STAFF RECOMMENDATION
1815 Sweetbriar Avenue
July 17, 2019

Application: New Construction—Addition and Outbuilding/Detached Accessory Dwelling Unit; Partial Demolition

District: Belmont-Hillsboro Neighborhood Conservation Zoning Overlay

Figure 4 (left) shows the enclosed porch and Figure 5 (right) shows the 1957 Sanborn map, indicated that this used to be an open porch.

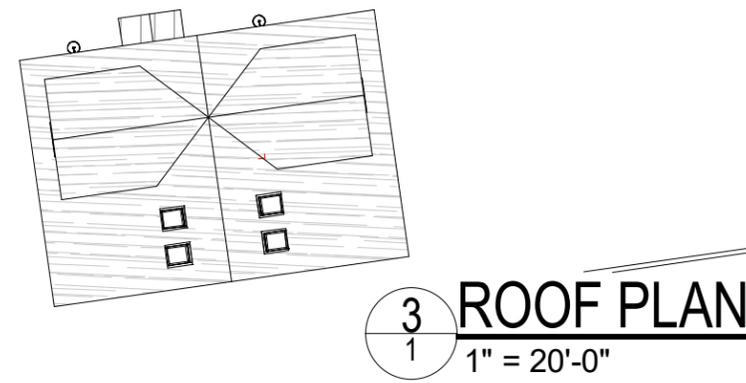
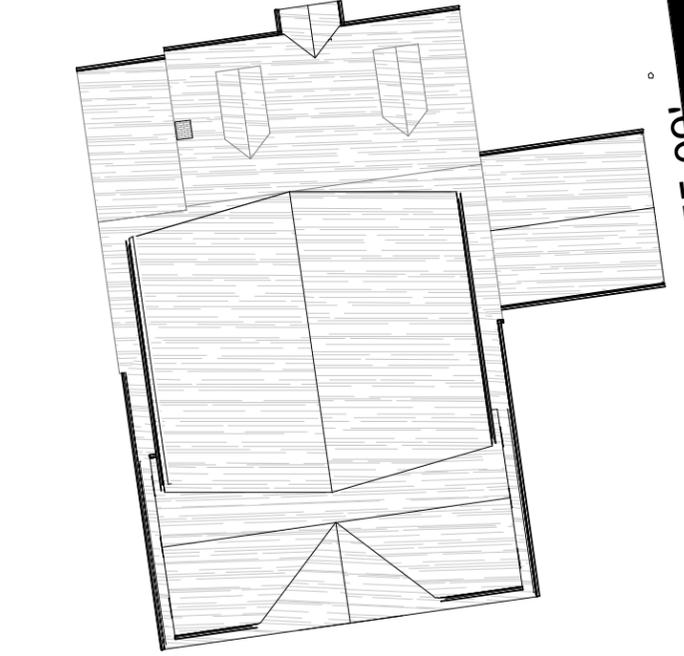
Demolition: The applicant intends to remove the front wall enclosure on the right hand side of the house (Figure 4). The 1957 Sanborn map shows that this area was originally

an enclosed porch (Figure 5). Staff therefore finds that removing this enclosure to recreate the front porch is appropriate and meets the design guidelines. The applicant will also be removing the non-historic metal awnings, which also meets the design guidelines.

Figure 6 shows the existing driveway on the left. The driveway will be relocated to the right side of the property.

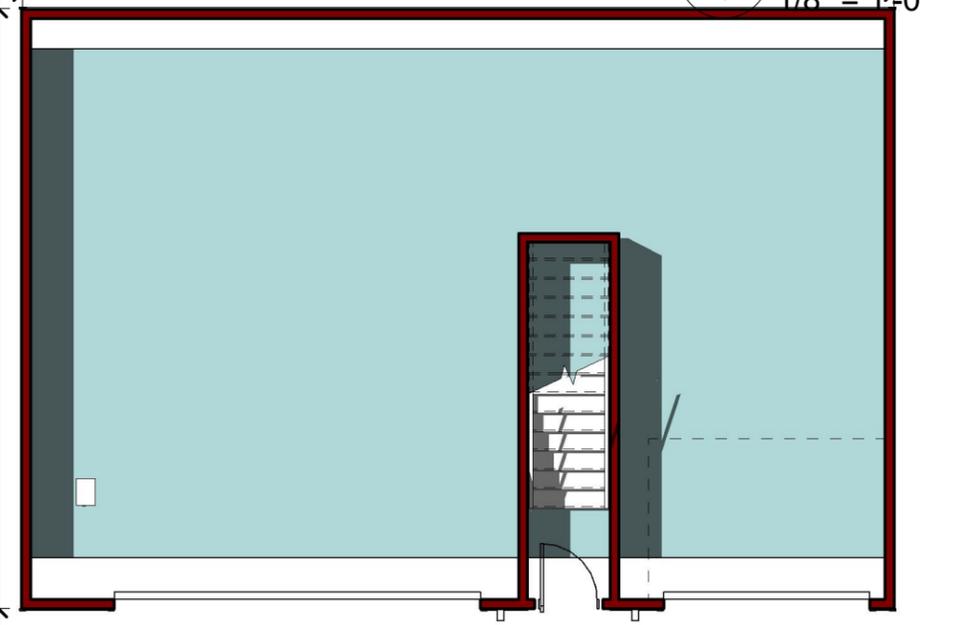
The existing driveway will be relocated from the left side of the property to the right side of the property (Figure 6). This will allow for the side addition on the left side, and for the driveway to reach the proposed DADU at the rear of the lot, on the right side. Staff notes that the site plan does not show the driveway and recommends that a condition of approval be that the site plan include the driveway plan.

With the requirement that the site plan show the new driveway plan, staff finds that the addition’s orientation to meet Sections II.B.1.f. and II.B.2. of the design guidelines.
